DEFENSE NUCLEAR AGENCY

ARMED FORCES RADIOBIOLOGY RESEARCH INSTITUTE
BETHESDA, MARYLAND 20889-5145

SUBJECT: Submission of Annual Report

1990
ANNUAL REPORT

FIGURE #2: AFRRI REACTOR SCRAMS

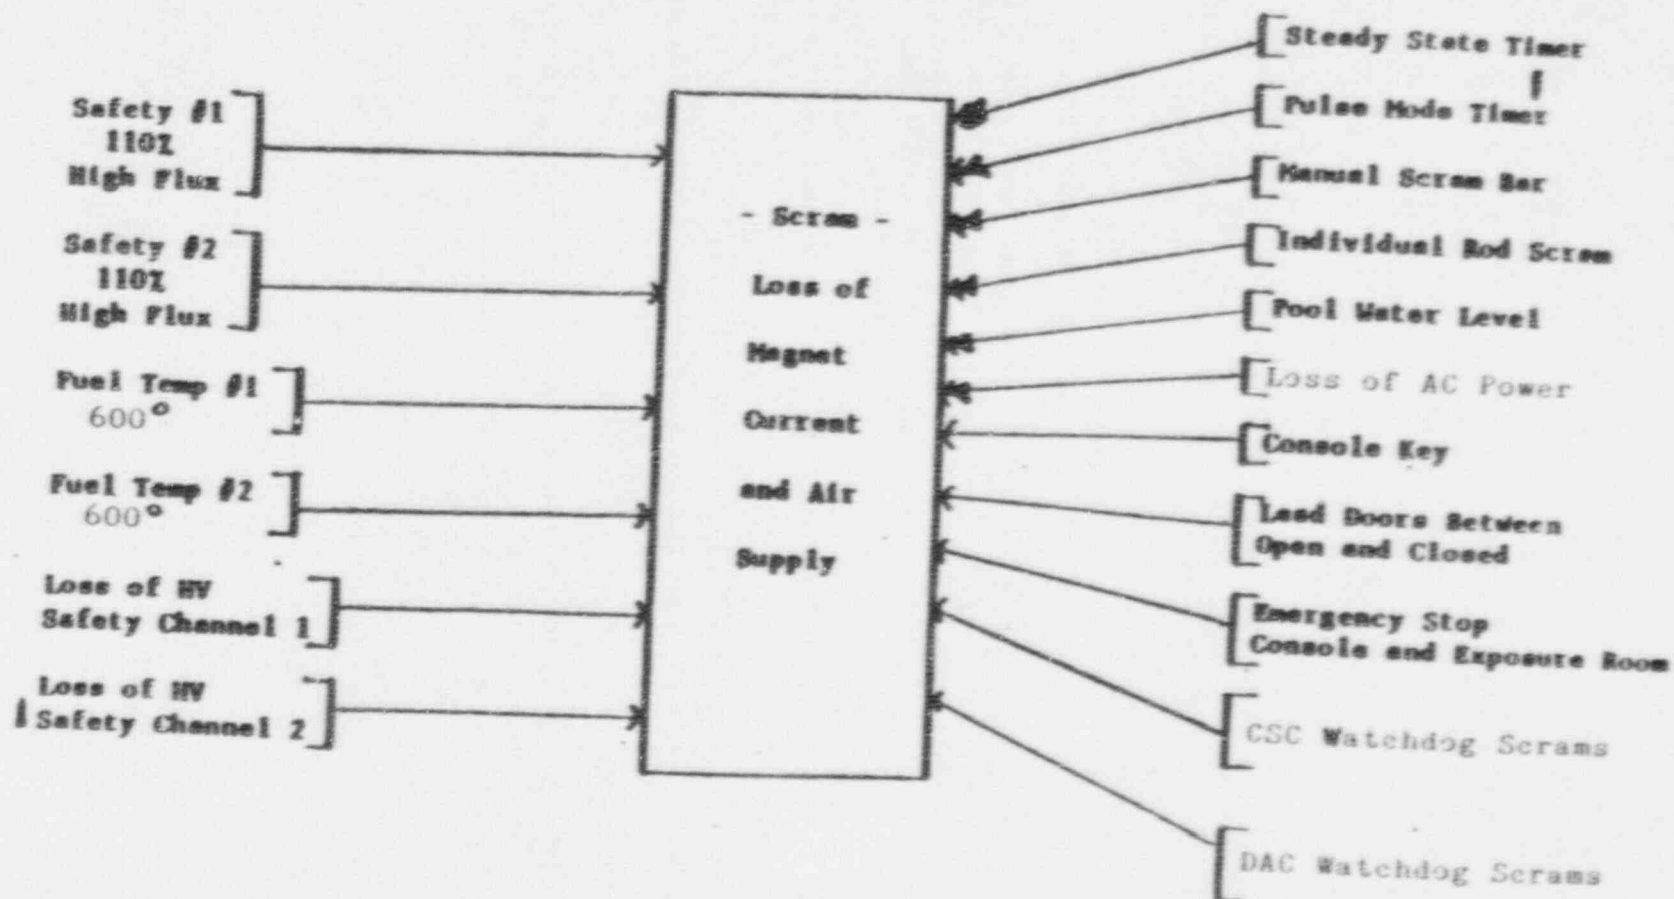
The scram logic circuitry (see Figure 2) assures that a set of reactor core and operational conditions must be satisfied for reactor operation to occur or continue in accordance with the technical specifications. The scram logic circuitry involves a set of open-on-failure logic relay switches in series: any scram signal or component failure in the scram logic, therefore, results in a loss of standard control rod magnet current and a loss of air to the transient rod cylinder, resulting in a reactor scram. The time between activation of the scram logic and the total insertion of the control rods is limited by the technical specifications to assure the safety of the reactor and the fuel elements for the range of anticipated transients for the AFRRI TRIGA reactor. The scram logic circuitry causes an automatic reactor scram under the following circumstances:

FIGURE #1
AFRI TRIGA MARK F
CONTROL SYSTEM
BLOCK DIAGRAM

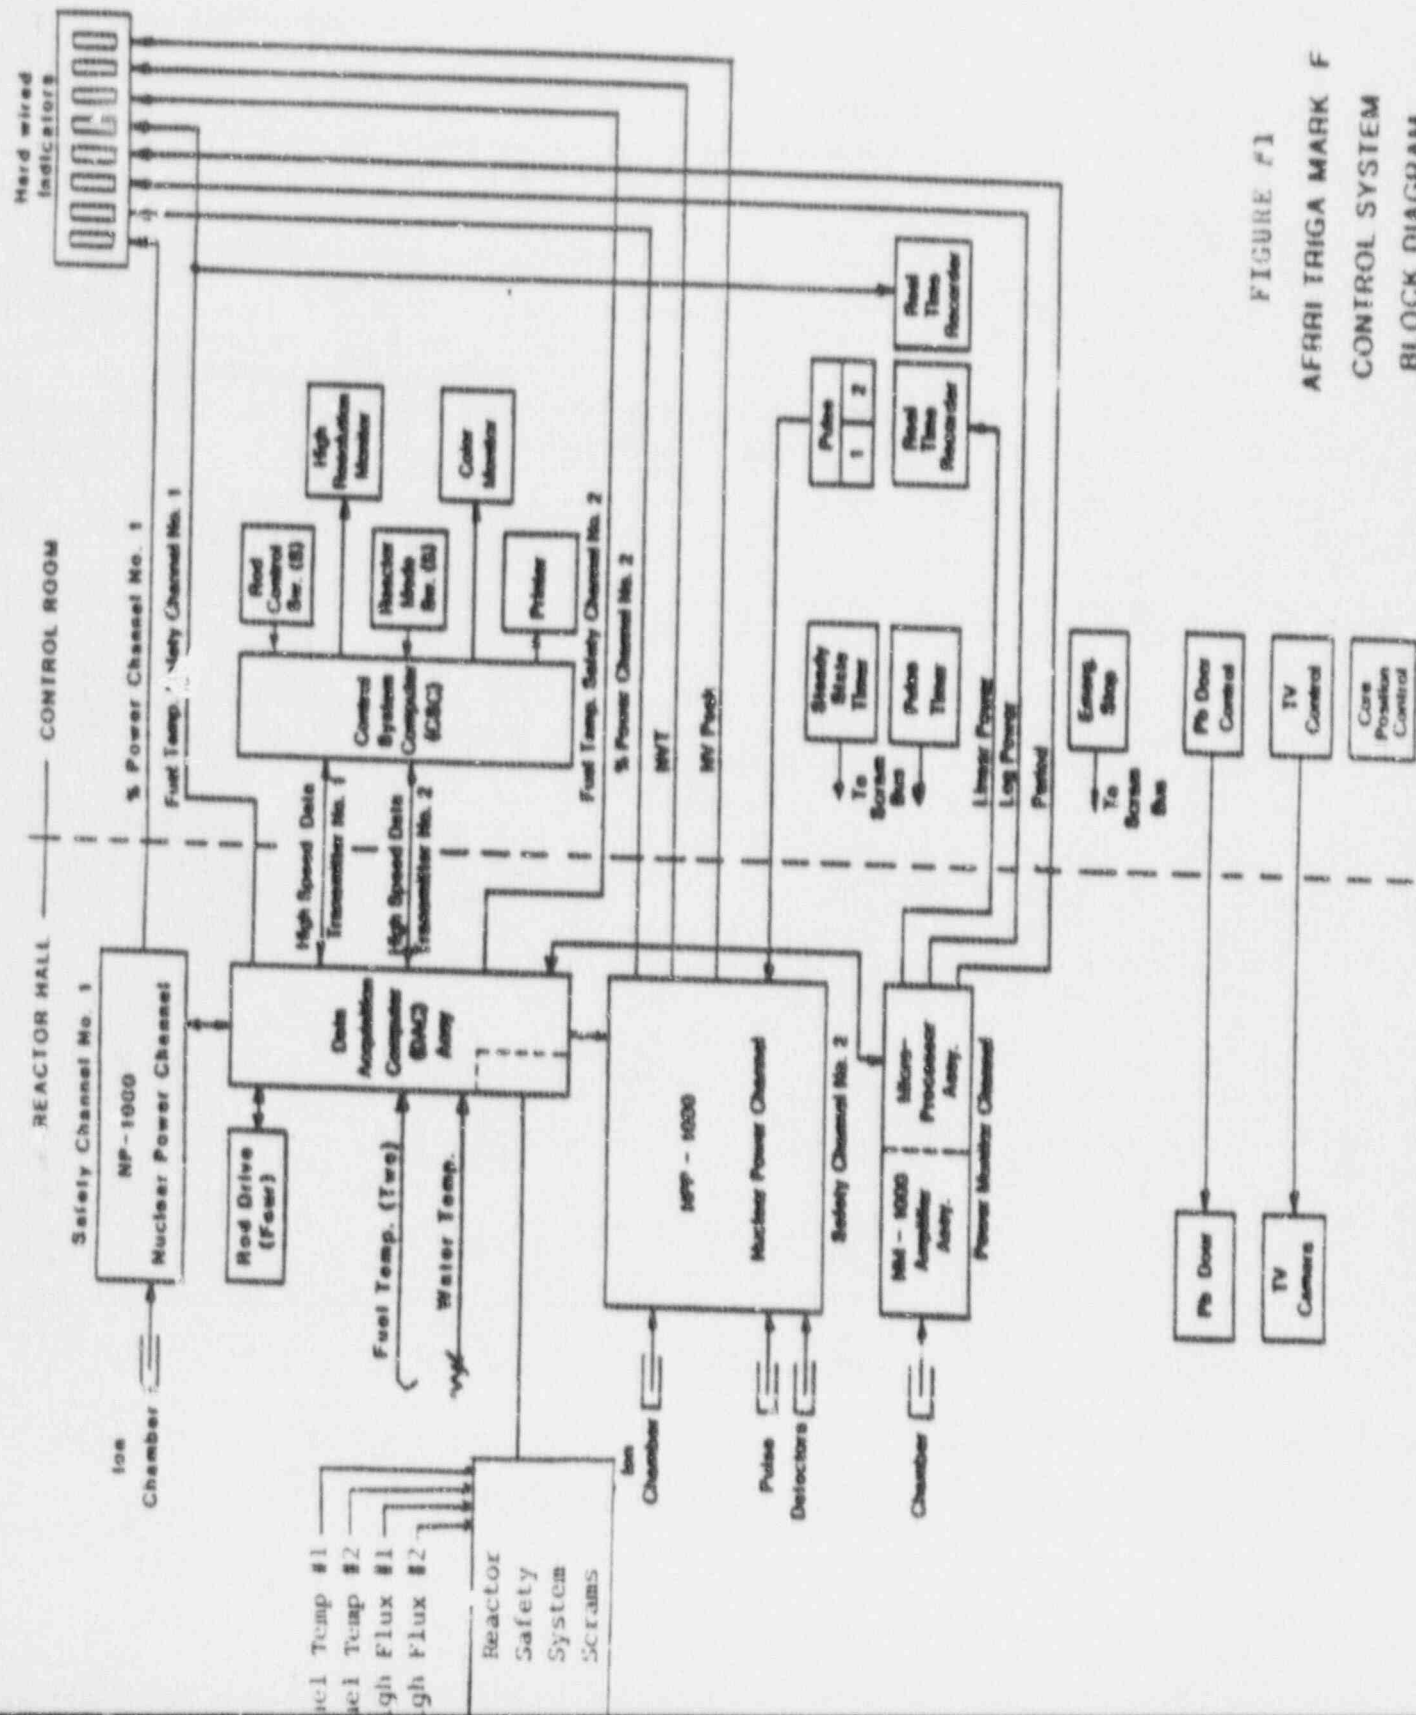
The basic elements of the new Reactor Instrumentation and Control System (see Figure 1) will consist of a Control Console, a Data Acquisition and Control Unit (DAC), two independent Power Monitor and Safety Systems, an Operational Channel, and a Pulse Channel. This system was design and built in accordance with ANSI/ANS-15.15-1978 "Criteria For The Reactor Safety Systems of Research Reactors".

FIGURE 4-8
STANDARD CONTROL ROD DRIVE
FOR SAFETY AND SHIM RODS*

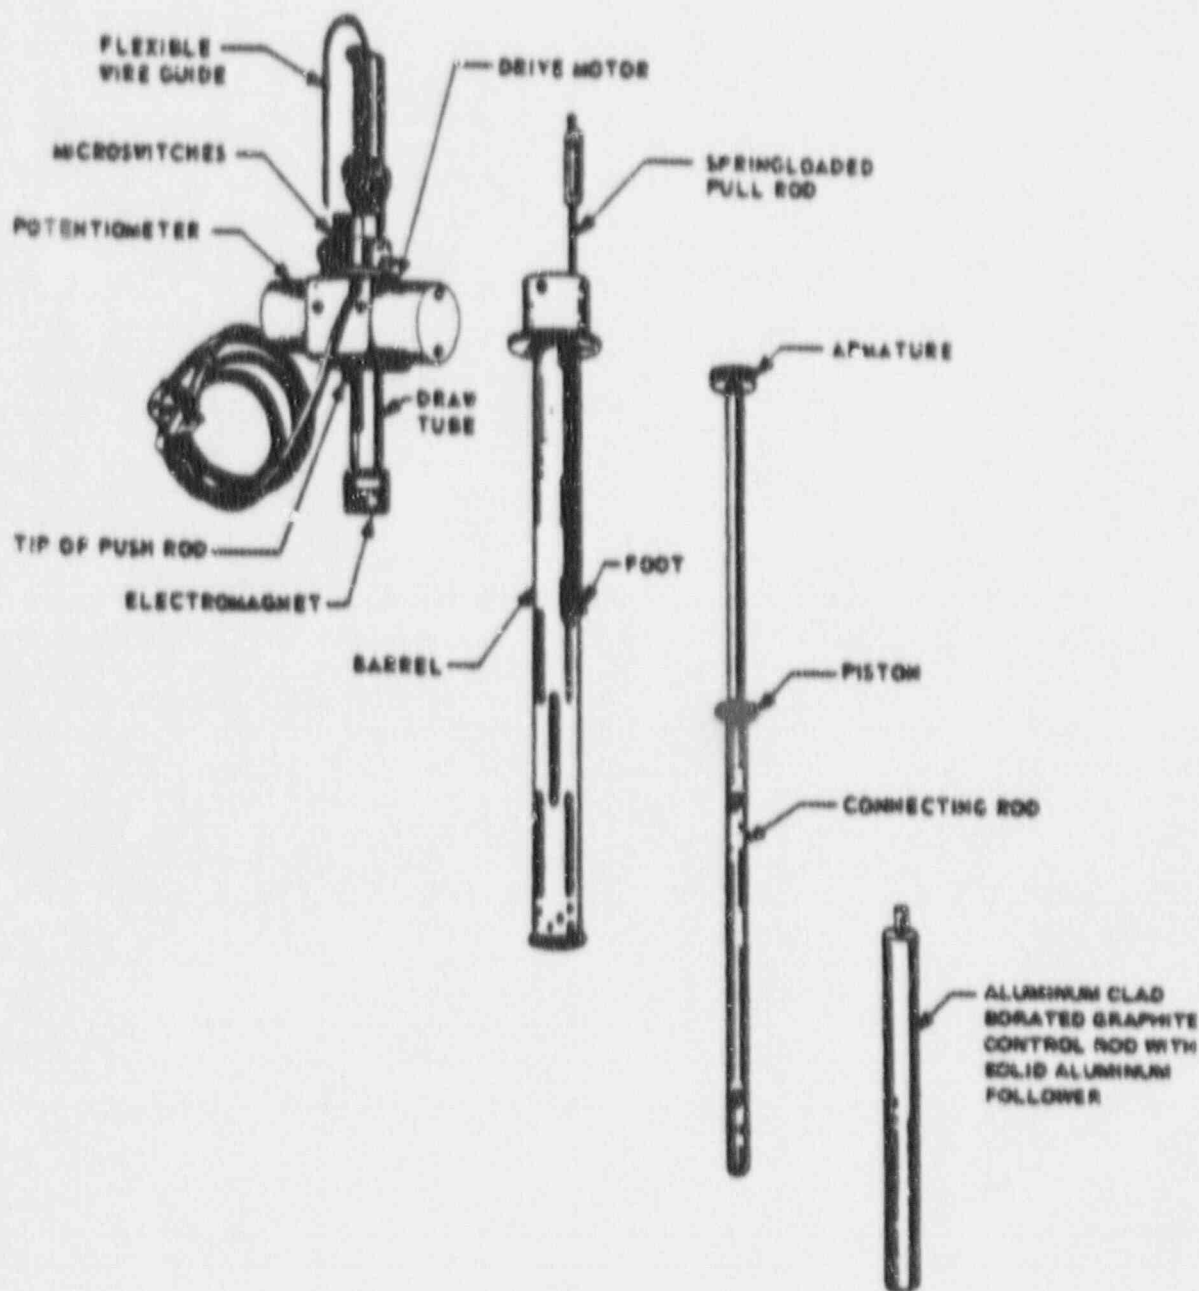
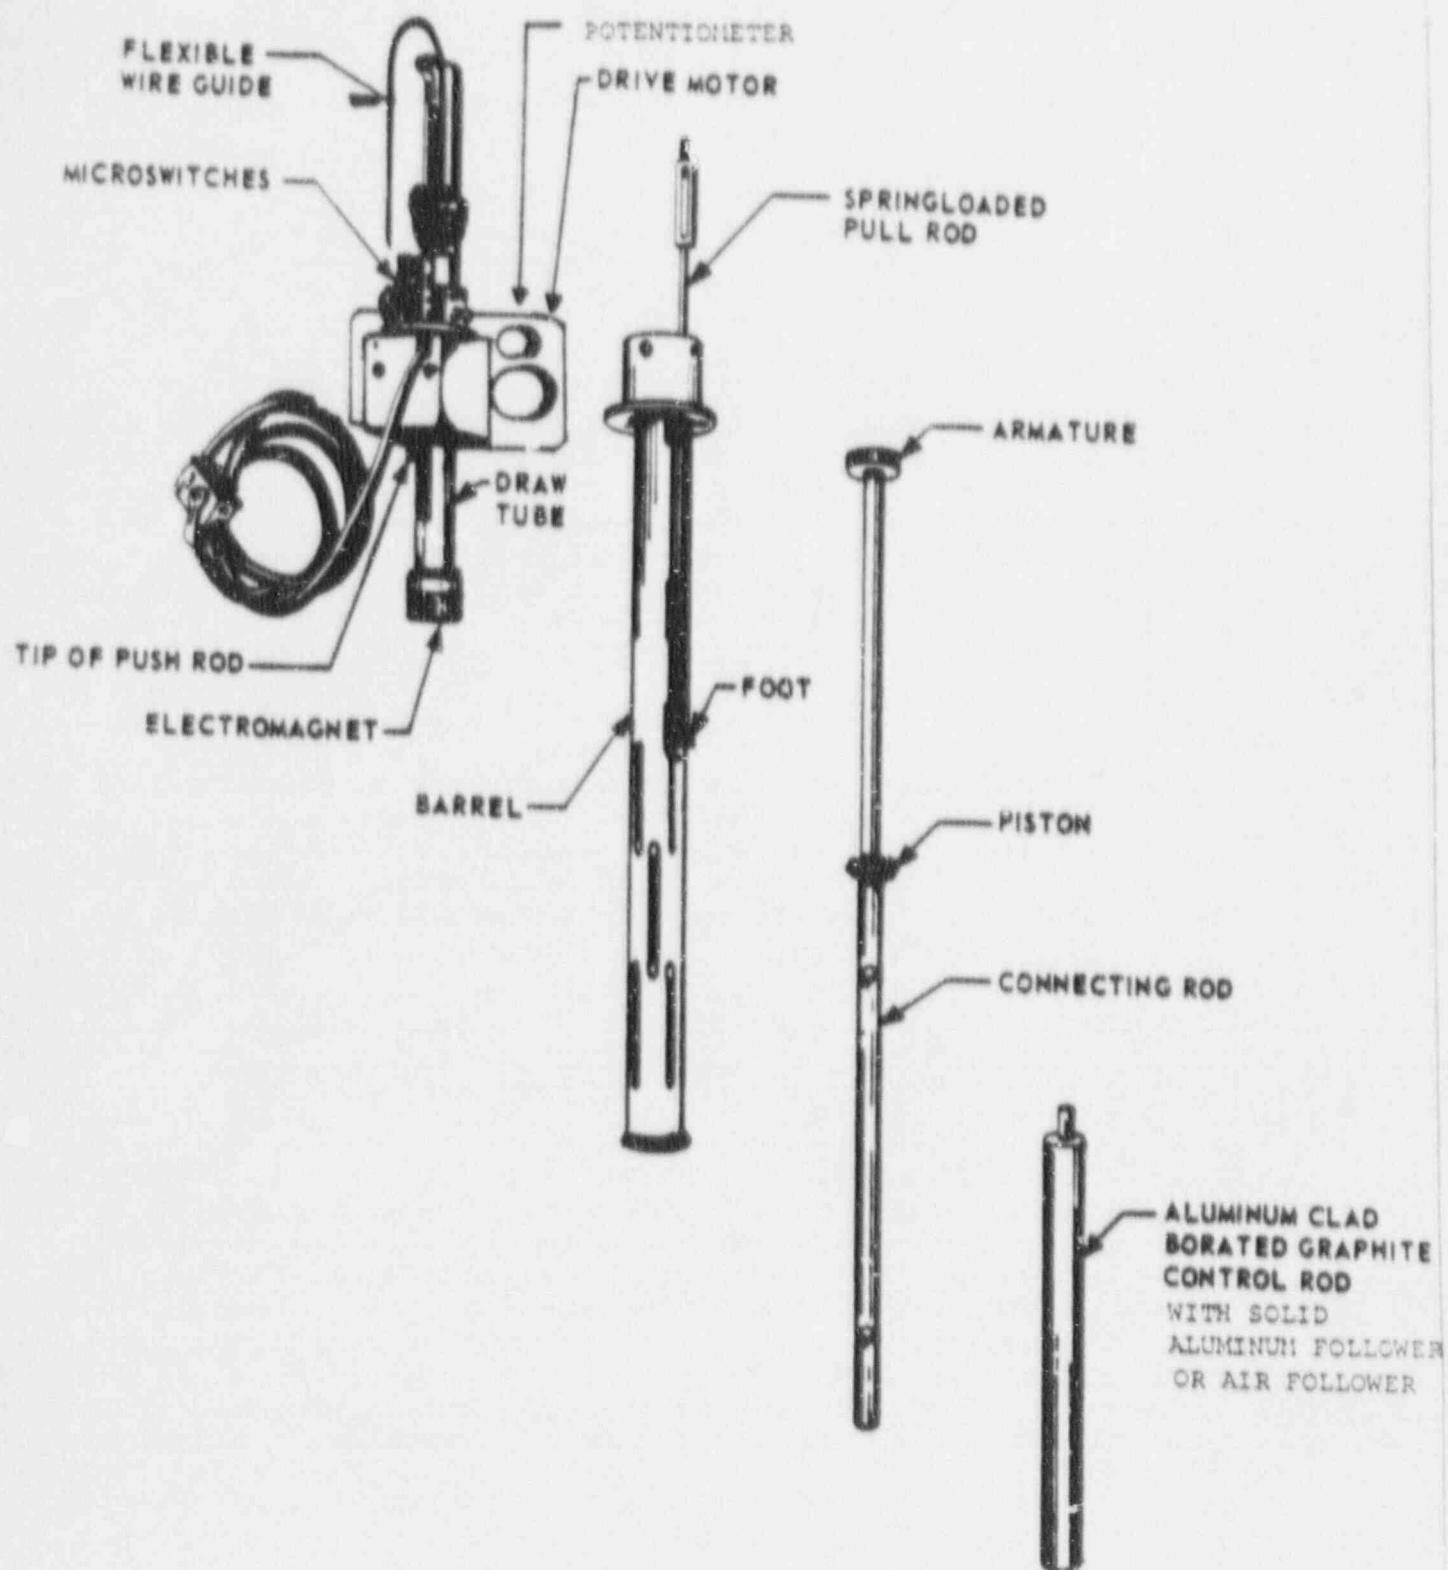
a. CURRENT SAR FIGURE:

Figure 4-8

PROPOSED SAR FIGURE:

Figure 4-8 (modified to reflect new control rod drives)

"The standard drive consists of a two-phase motor, a magnetic coupler, a rack and pinion gear system, and a potentiometer used to provide an indication of rod position, which is displayed on the reactor console."

"The standard drive consists of a stepping motor, a magnetic coupler, a rack and pinion gear system, and a potentiometer used to provide an indication of rod position, which is displayed on the reactor console CRT."

"When the stepping motor is energized, the pinion gear shaft rotates, thus raising the magnet draw tube."

FIGURE 5-1
 EXPOSURE ROOMS

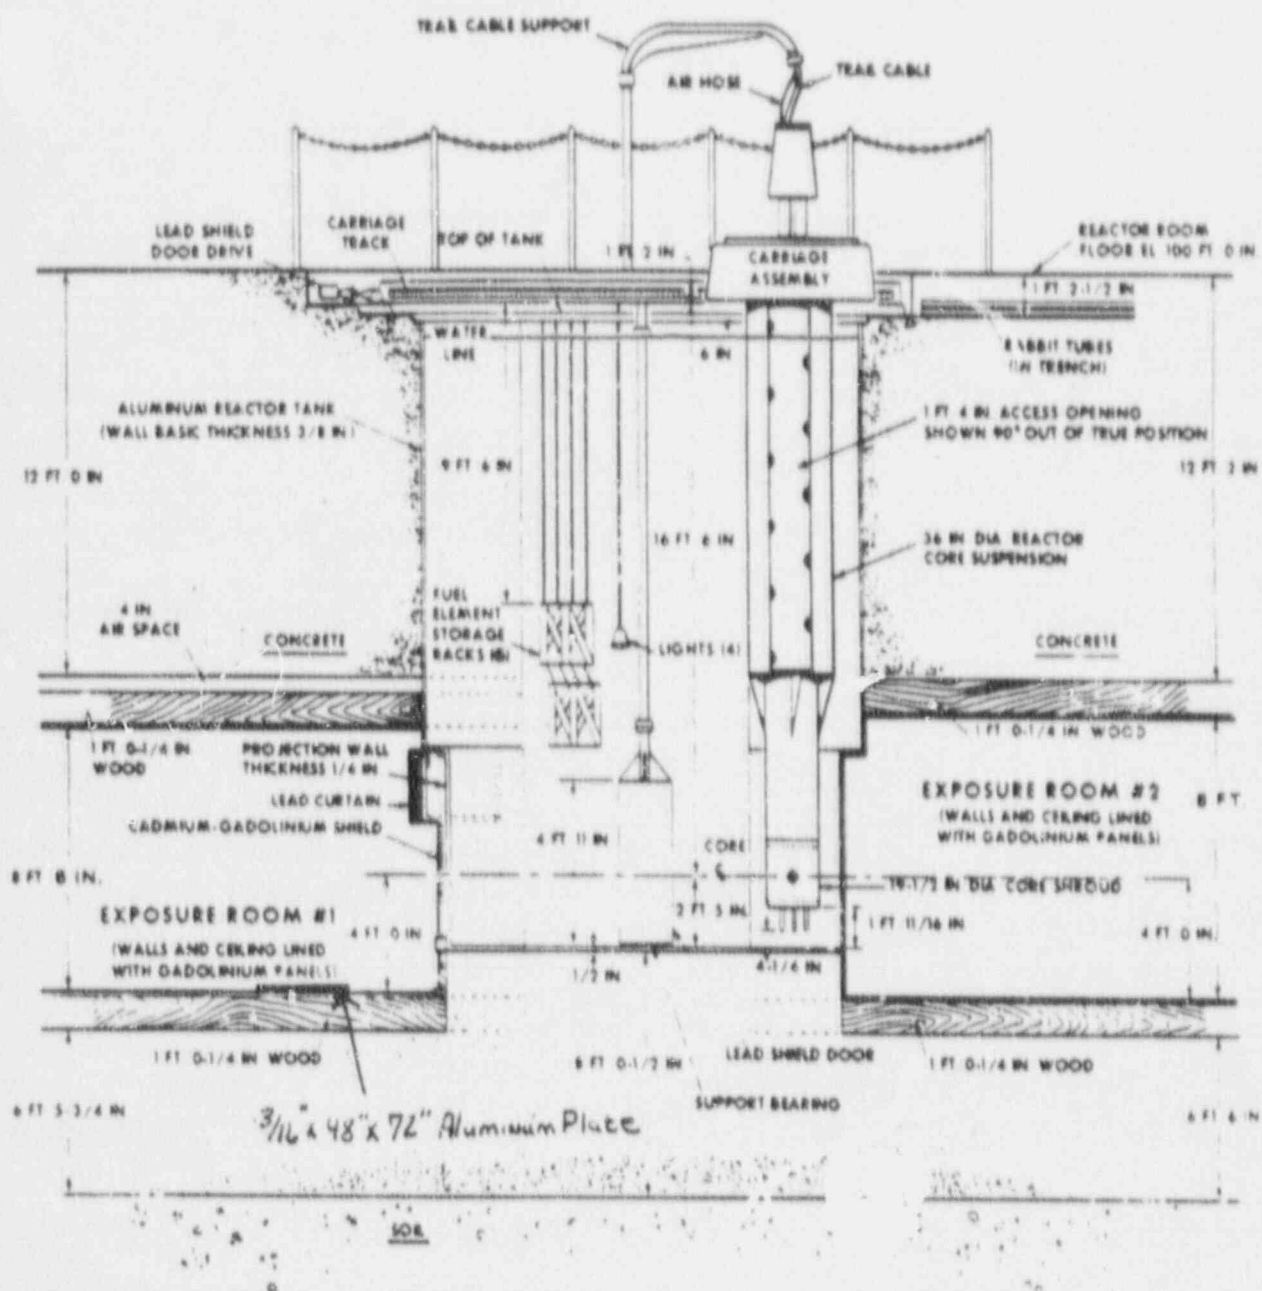
- g. The SAR wording would require the following addition at the end of Section 5.2.1:
"Exposure Room #1 has a removable 3/16" x 48" x 72" aluminum plate which may be placed on the floor in front of the core projection to minimize wear to the wood floor by the wheels of the experiment holding tables."

- h. See attached updated drawing.
